Job Title The Farmers Stores, Gatehouse Lane, Goddards Green, Hassocks, BN6 9LE.		Date 01/12/2025
Item Gatehouse Hub 2 – Mid Sussex District Council Flood Risk and Drainage Team Response Note	Job No. E9427	Report No. RE003 A

MSDC Flood Risk and Drainage Team Comments (30 October 2025)

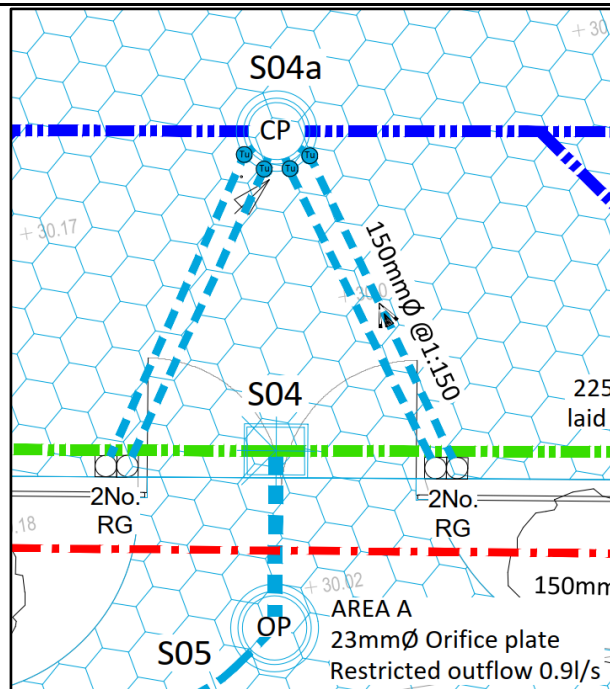
- 1. The depth of water within the permeable paving for catchments B and C exceeds that of the gravel sub-base.*
- 2. Further information should be provided to demonstrate that the proposed SuDS features are adequately sized.*
- 3. It appears that the road gullies discharge downstream of the Area A's orifice plate, and this flow does not appear to be attenuated. Please provide further information.*
- 4. Given the size of the development, we require the level of detail within the drainage calculations to match that within Phase 1 (DM/24/0421).*
- 5. For consistency we would recommend checking that all permeable paving depths are correct throughout the submission.*

Whilst we feel that the current drainage is adequate and meets Mid Sussex guidance effectively, in the interest of addressing this comment and avoiding recurring conversations and delays, the subbase depths will be increased as follows.

Area	Depth of Water (mm)	Depth of Subbase Material (mm)		Increase (mm)
		Current	Proposed	
A	666	750	750	Nil
B	831	750	870	120
C	951	800	960	160

The above table indicates that the maximum water level within the permeable paved areas does not exceed the type 3 gravel subbase material. We trust that addresses this comment satisfactorily.

2. The depth of permeable paving subbase has been increased to ensure that during the worst design case storm, 1:100 plus 45% Climate change, the depth of water does not exceed the depth of the gravel subbase material as highlighted in the table above.

3. The orifice plate has been moved to manhole reference S05 and road gully lateral have been rerouted to new manhole and perforated distribution pipe, see below. Refer to 9427-SWP-ZZ-XX-DP-C-1100 & 1101 P03 and manhole schedule drawings 9427-SWP-ZZ-XX-SH-C-1105 P02.
